Option C

SBRC FEEDBACK

School Boundary Review Criteria

T_{CB} Proposed Boundaries

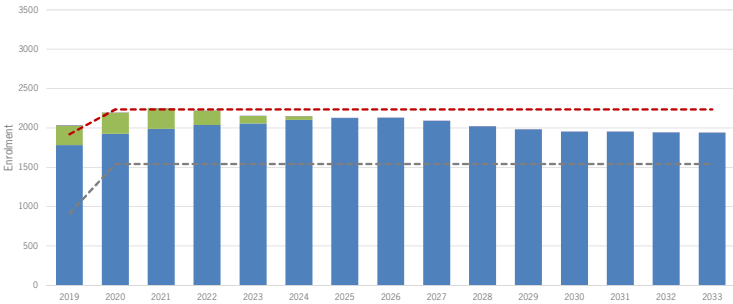
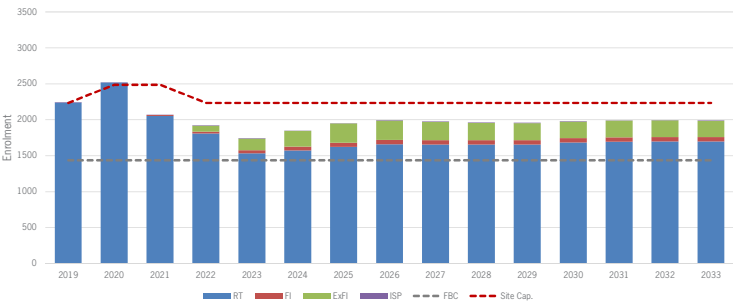
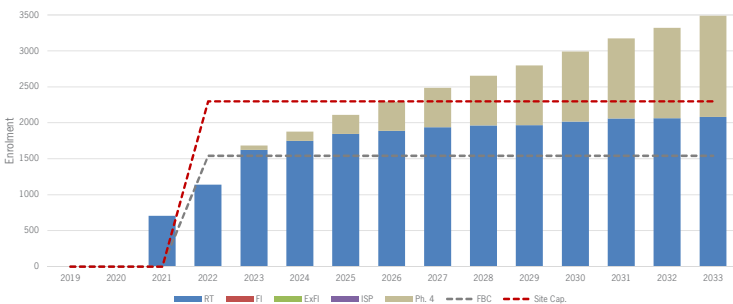
NO	SOMEWHAT	YES
1. Optimize the use of existing school facilities?			✓3
2. Minimize the use of portable classrooms?	✓1	✓1	✓1
3. Minimize school boundary adjustments over the long-term?	✓2	✓1	
4. Maximize walkers to school and minimize transportation needs?	✓1	✓2	
5. Ensure that school populations are sustainably sized?		✓2	✓1 Except for QoH
6. Give due consideration to the concept of neighbourhood and Catholic school communities?	✓2		✓1 Except for QoH

- Specialty programs not moving ✕
- Transportation (except Q of H) ✕
- Closest to Parish boundaries ✕

- NW to SE – Queen of Heaven at disadvantage – not going to school in current community ✓
⇒ And bused further than they currently are ✓
- Too long of a bus ride for QoH (early pick up late return) ✓

- Minimize long term changes ✓
- Will Milton Heights development affect plans – more growth
⇒ This has been considered/included
